RE: Addendum No. 1 – Fort Bend County BID 25-067 – Construction of Mustang Park Community Center Renovation and New Construction in Precinct Two

PURPOSE: This Addendum includes miscellaneous revisions, clarifications, and updates to the construction documents across multiple disciplines, including Architectural, Civil, Landscape, MEP, A/V, and Technology. All changes supersede previously issued drawings and specifications where applicable.. The summary below outlines the revisions made to the applicable drawing sheets to reflect this change.

Sheet Title:
STORM SEWER CALCS

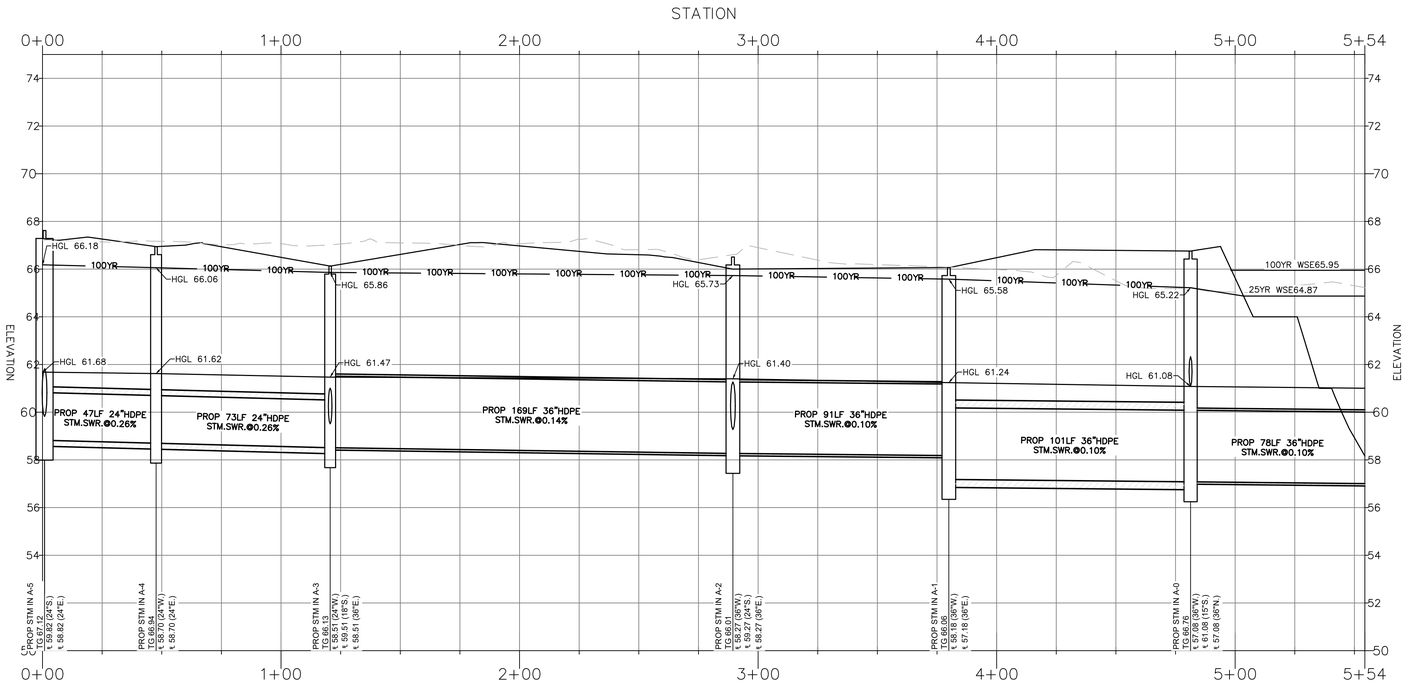
9. C204.01: New sheet added
10. C204.02: New sheet added with plan and profile and the outfall structure details
11. C205: Calculations updated
12. C206: Updated 10yr and 25yr wse
13. C207: Updated 10yr and 25yr wse, orifice structure details removed
14. C208: updated grading for the fireline changes
15. C209: updated grading for the fireline changes and relocated pump pit
16. C301: Fire water line, Vault with FDC taps, easements, fire hydrants and rpz and check valve relocated and/or added
17. C401: Fire water line, Vault with FDC taps, easements, fire hydrants and rpz and check valve relocated and/or added, Location markers updated
18. C402: location markers updated
19. C501: New sheet added
20. C502: New sheet added
21. C606: Pump Details and storm box updated
22. C608: Details for water RPZ and fdc updated
23. C609: New details added
24. C610: New details added

Sheet Title:
UTILITY PLAN

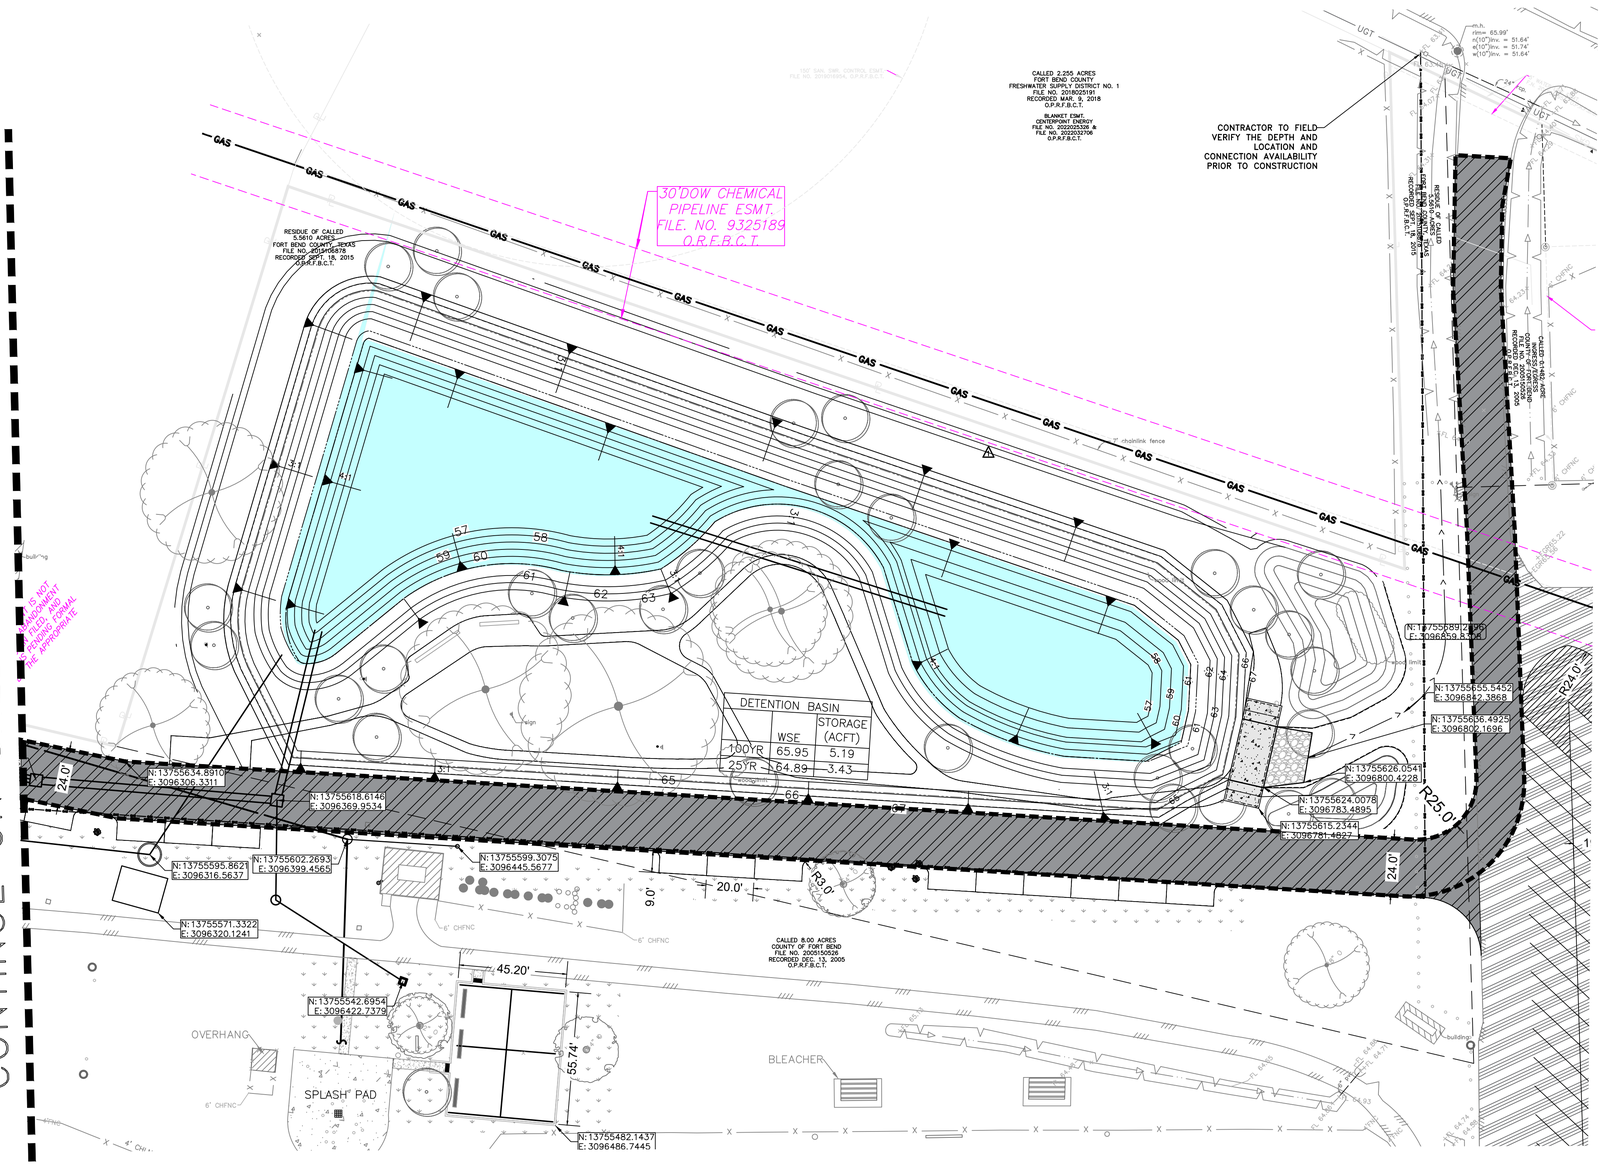
Question 14: E100 note 7 states to see civil and mechanical drawings for PIV locations. PIV's are not noted on C301 or M100. Please indicate the PIV locations.

Answer: Vault locations for the PIVs will be identified on revised sheet C301, and corresponding vault details will be provided on revised sheet C608. Both sheets will be issued as part of forthcoming Addendum #1.

Sheet Number
A-M101

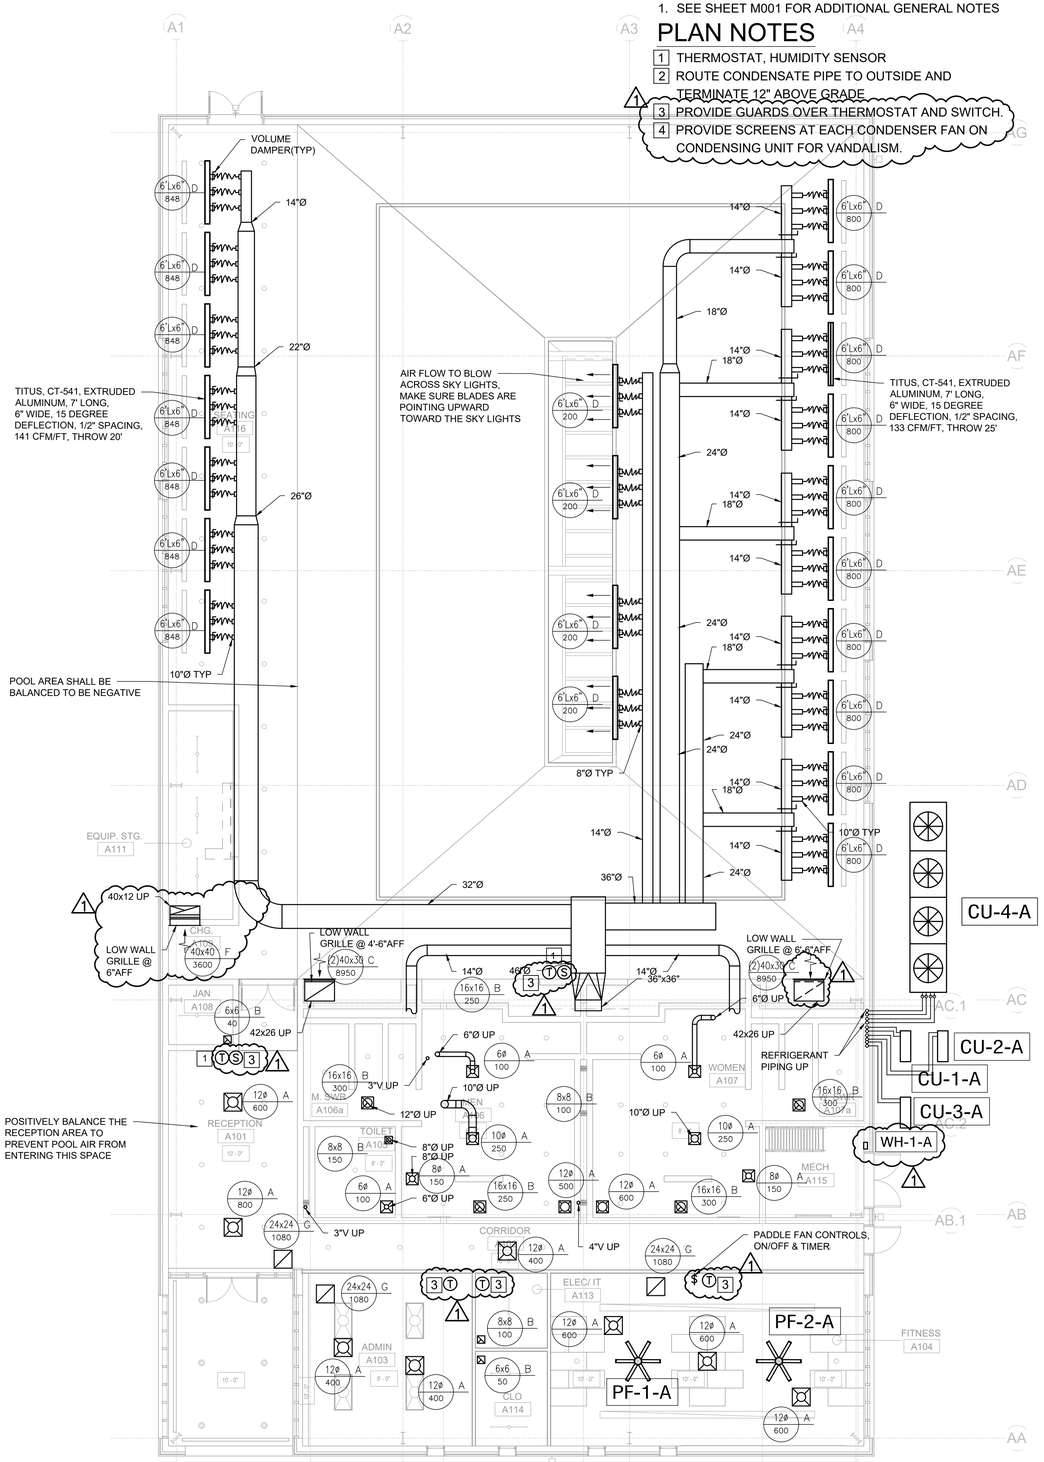
1. A-M101:
    a. ADD Propellor Fan Schedule.
2. A-M201:
    a. Plan Notes Add note 3, provide guards over thermostats and switches, and Add note 4, Provide protective / security screens at each condenser fan on condensing units for vandalism.
    b. Changing Room A109, rotate 40x12 AL duct up and exhaust grille from east wall to south wall.
    c. Reception A101, See plan note 3.
    d. Pool, See plan note 3.
    e. Admin A103, See plan note 3.
    f. Fitness A104, See plan note 3.
    g. Mech A115, Add wall heater WH-1-A.
    h. Grid A4 & AC, adjust 42x26 to clear beam above into Mech Room.
3. A-M202:
    a. Mech Room Equipment Plan: 42x26 duct adjusted to clear beam in mech room.
    b. Pump Room HVAC Plan: Location of boiler combustion and flue through roof.
    c. Pump Room Roof Plan: Flue through roof location.

B-E201

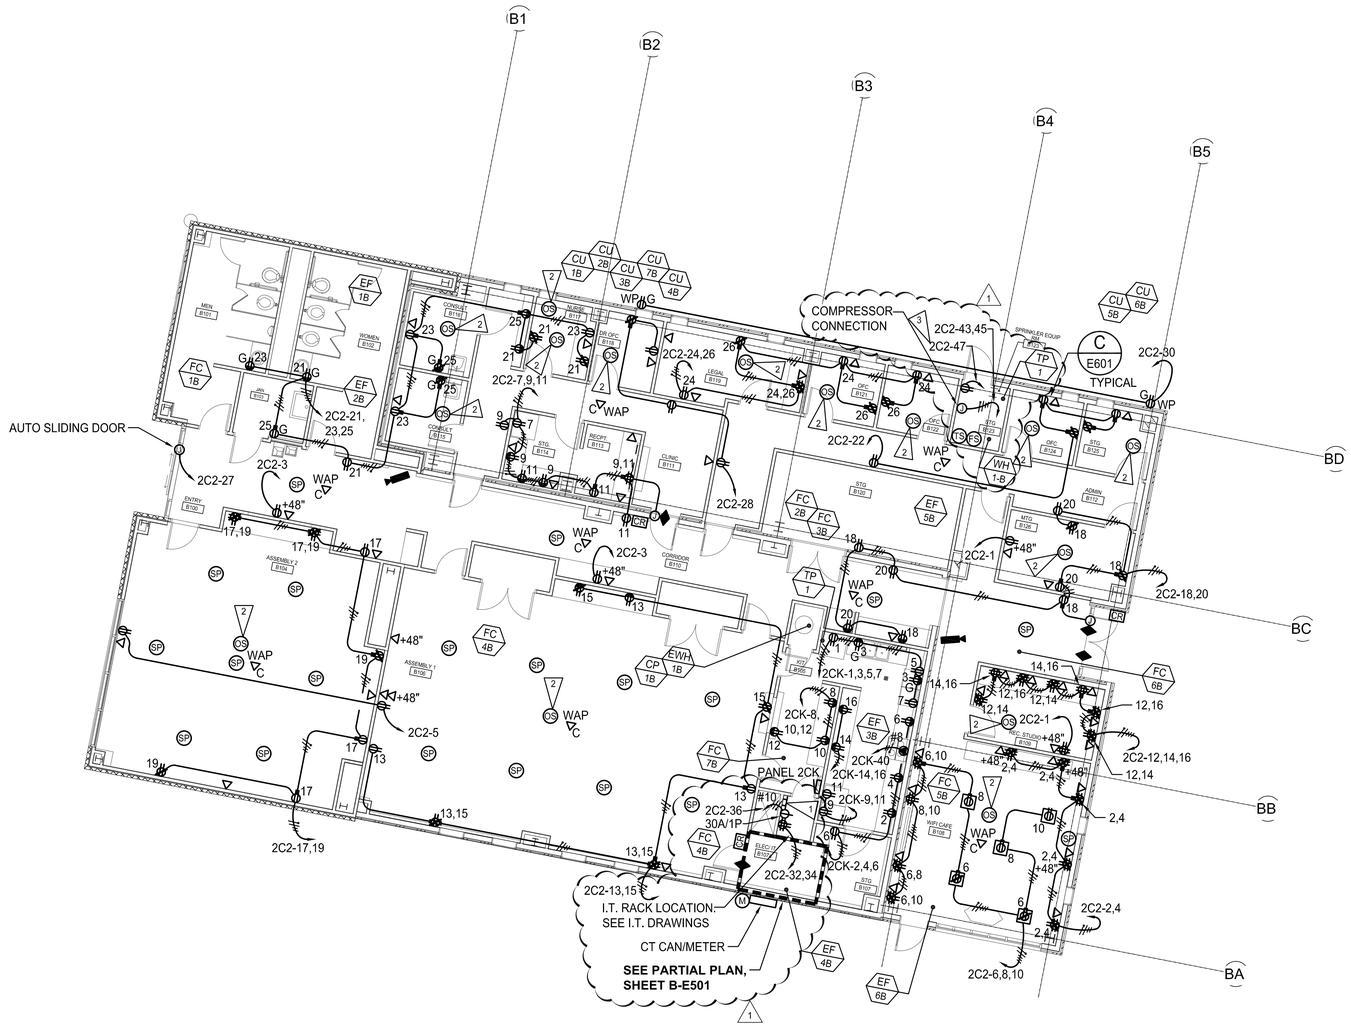
6. A-E5.01: Updated panel schedule 2N2.
7. A-E5.02: Updated mechanical equipment connection schedule to include new wall heater.
8. B-E2.01: Updated lighting to match Architectural Floor plan changes.

P002

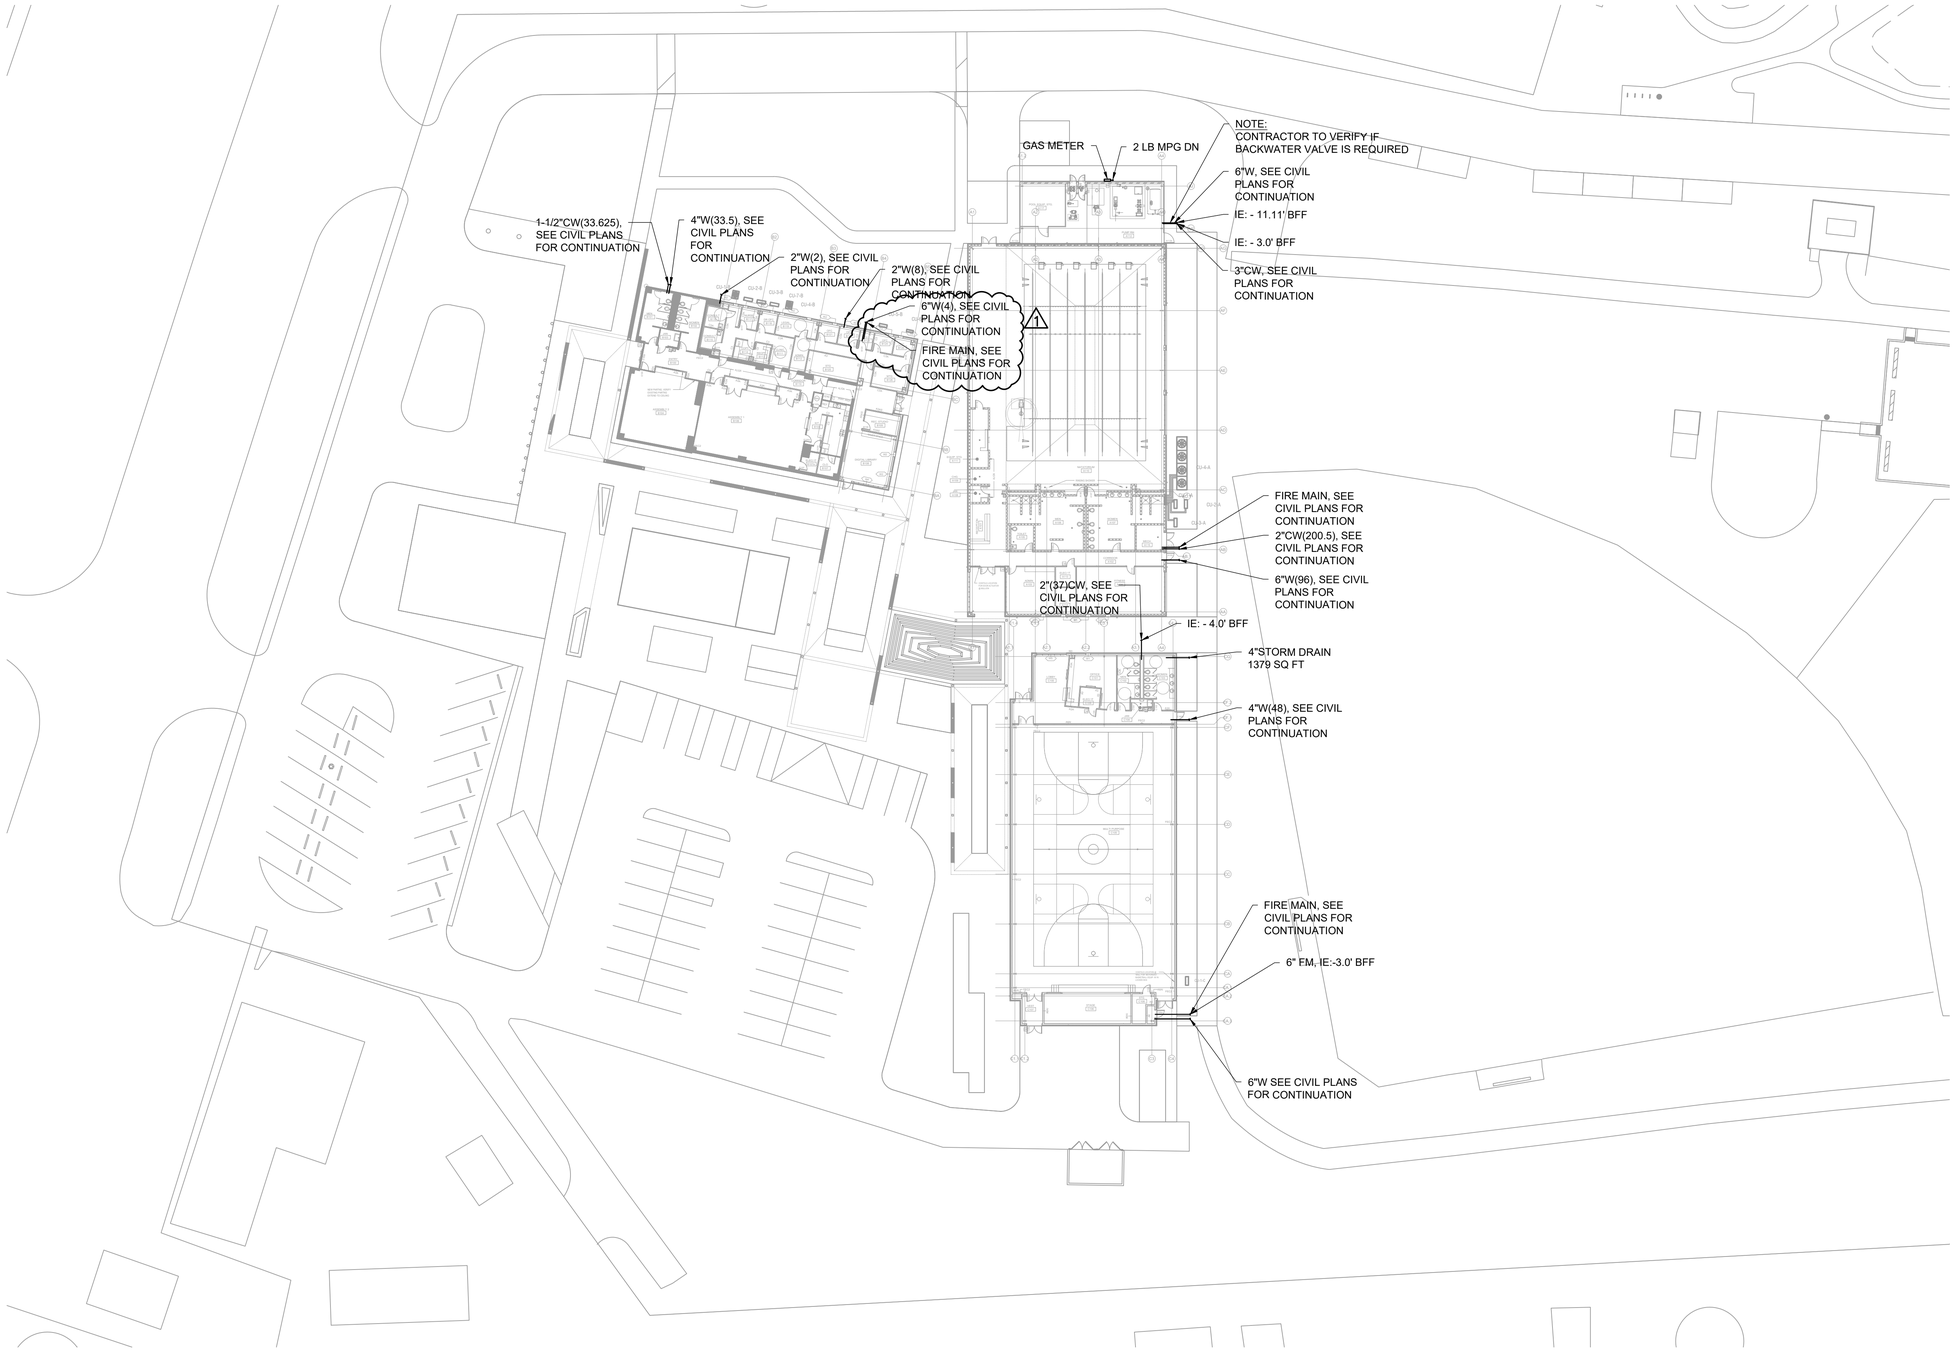
1. P002:
    a. WC-2 correct make and model number.
    b. UR-1 correct make and model number, correct flush valve.
    c. FD-1 correct make and model number.

B-P200

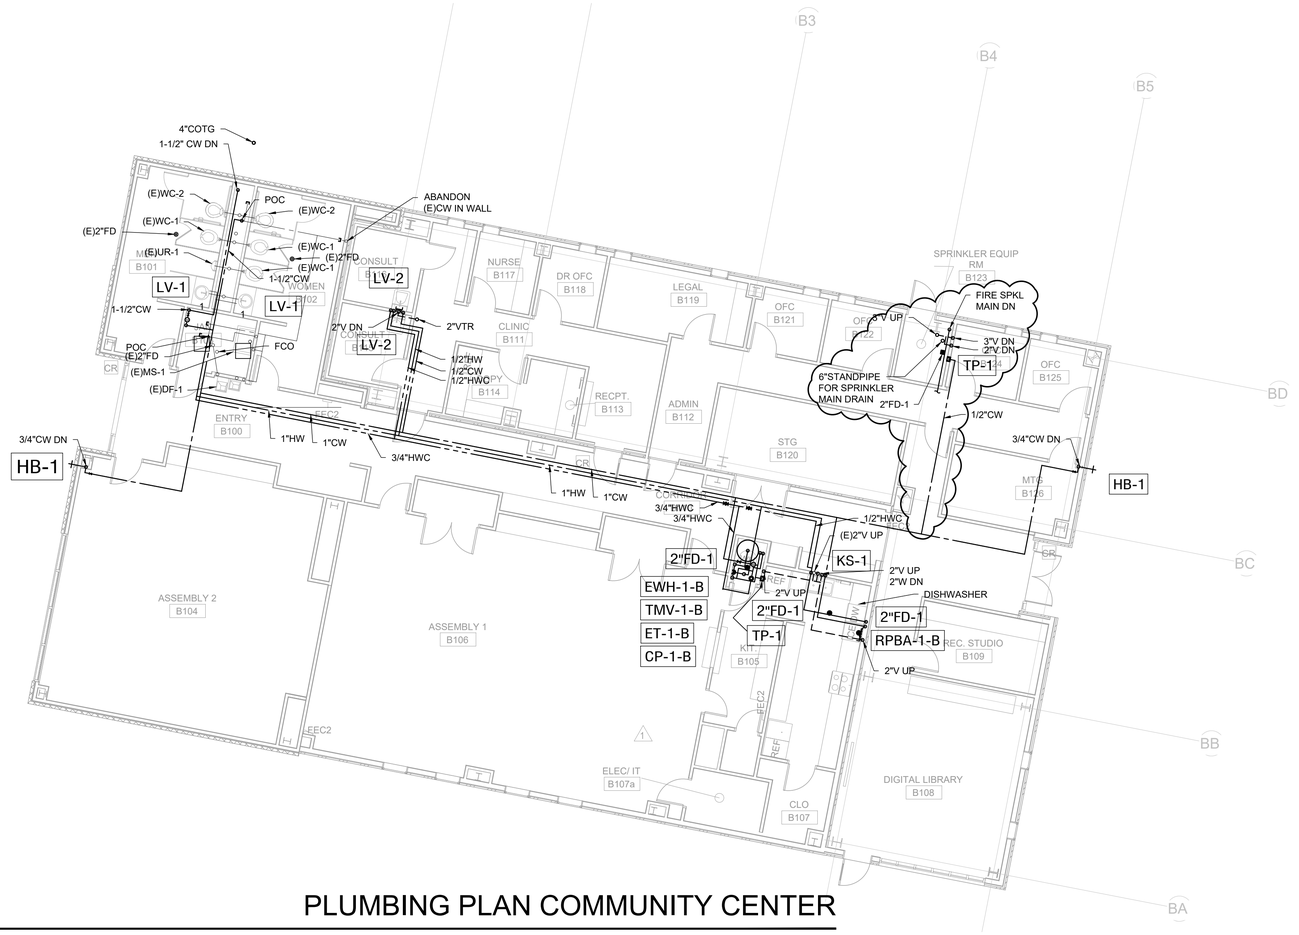
a. Add Trap primer, 6” standpipe, 3” vent, 2” FD-1, and fire sprinkler main in the sprinkler equipment room B123.
